Affected Publication: API Specification 6A, *Specification for Wellhead and Christmas Tree Equipment*, Twentieth Edition, October 2010

ADDENDUM 2

Annex O (normative)

O.1 Technical Modifications to ISO 10423:2009

Figure 6 — Hardness test locations for weld overlays

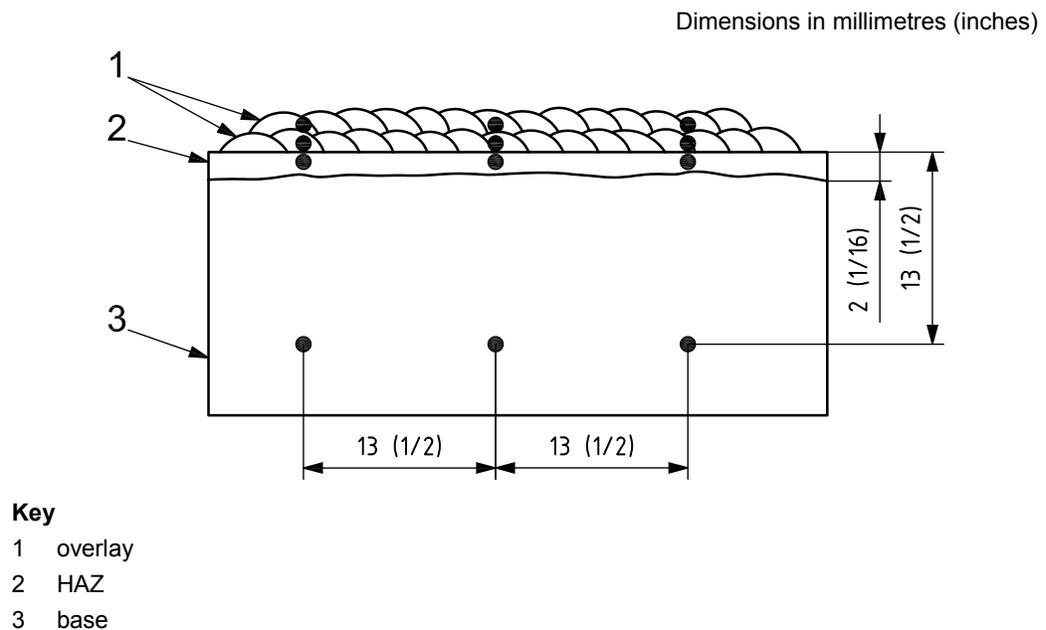
6.5.1.1.2

Replace the entire subclause with:

Welds for use in hydrogen sulfide service shall conform to the requirements of ISO 15156 (all parts) (NACE MR0175; see Clause 2). If the welding procedure is to be qualified for use on bodies, bonnets or flanges used for material classes DD, EE, FF or HH, hardness testing shall be carried out by the Rockwell method in accordance with ISO 6508 (all parts) or ASTM E18, or the Vickers 98 N method in accordance with ISO 6507 (all parts) or the Vickers 10 kgf method in accordance with ASTM E92. Hardness tests shall be performed at a minimum of three test locations in each of the base material, the heat-affected zone and in each layer of overlay up to a maximum of two layers. See Figure 6 for required hardness test locations.

“6.5.1.1.2 Welding procedure/performance qualification

Qualification shall be in accordance with ASME, BPVC:2004, Section IX, Articles II and III, for weld overlay.

- c) weld conformance to ISO 15156 (all parts) (NACE MR0175; see Clause 2):
